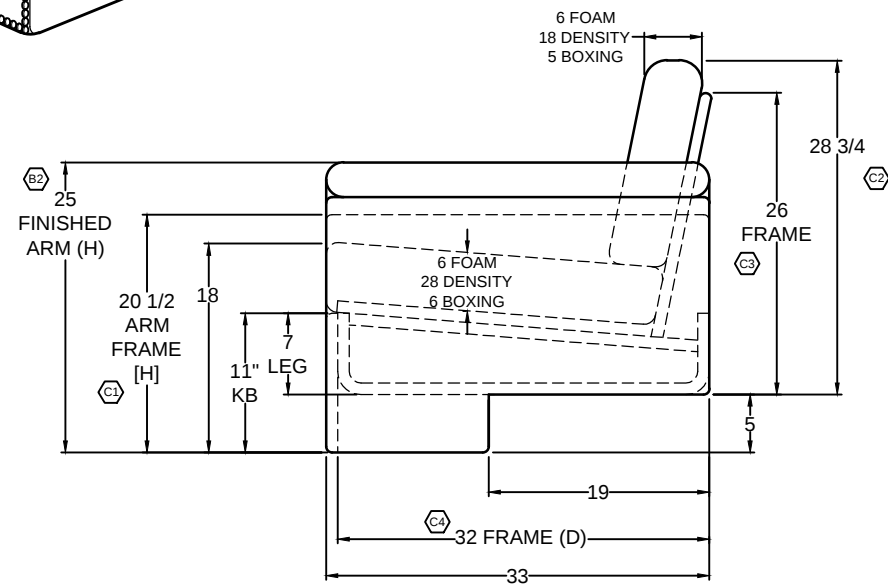
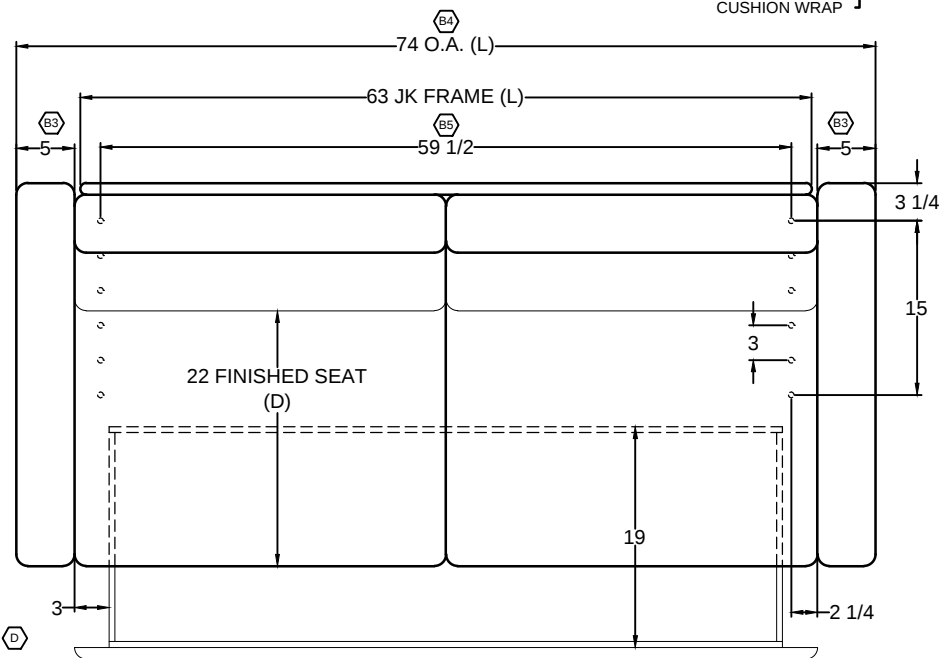
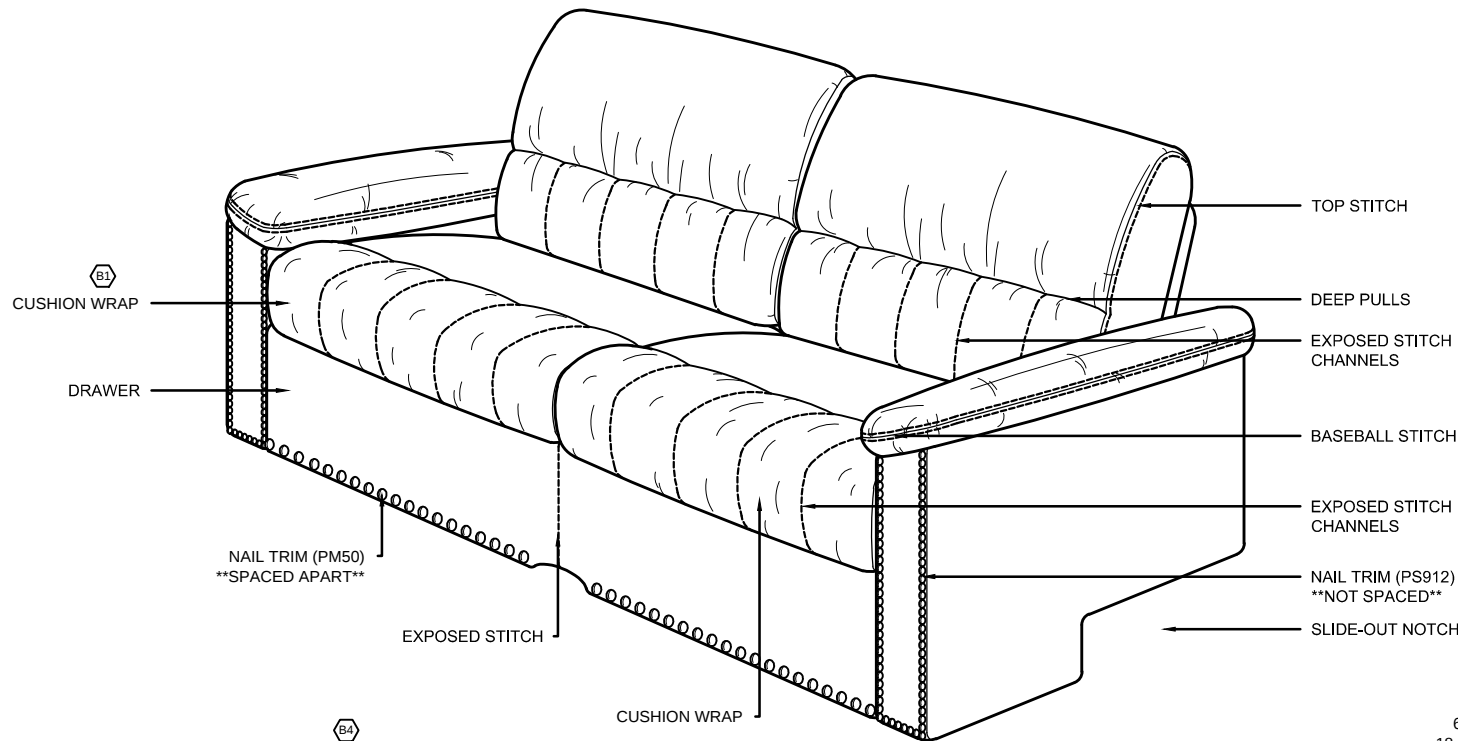
JA	D	PER NN, DRAWER STARTS 3" FROM THE INSIDE OF ARMS; WAS 8".	08.22.18
JA	C	PER FTBM, [1] ADDED 20-1/2" ARM FRAME HEIGHT, [2] ADDED 28-3/4" HEIGHT FROM SLIDE FLOOR DIMENSION, [3] ADDED 26" FRAME HEIGHT FROM SLIDE FLOOR DIMENSION, [4] CHANGED FRAME DEPTH TO 32"; WAS 33".	08.20.18
JA	B	[B1] RE-ADDED CUSHION WRAP TO SEAT, [B2] DECREASED FINISHED ARM HEIGHT TO 25"; WAS 26", [B3] DECREASED FINISHED ARM WIDTH TO 5"; WAS 6", [B4] INCREASED FRAME SIZE TO 63"; WAS 61", [B5] CHANGED BOLT DISTANCE TO 59-1/2"; WAS 57-1/2".	08.17.18
AC	A	[A1] REMOVED CUSHION WRAP FROM SEAT, [A2] INCREASED FINISHED ARM HEIGHT TO 26"; WAS 25", [A3] INCREASED FINISHED ARM WIDTH TO 6"; WAS 5", [A4] REDUCED FRAME SIZE TO 61"; WAS 63", [A5] CHANGED BOLT DISTANCE TO 57-1/2"; WAS 59 1/2".	10.12.17
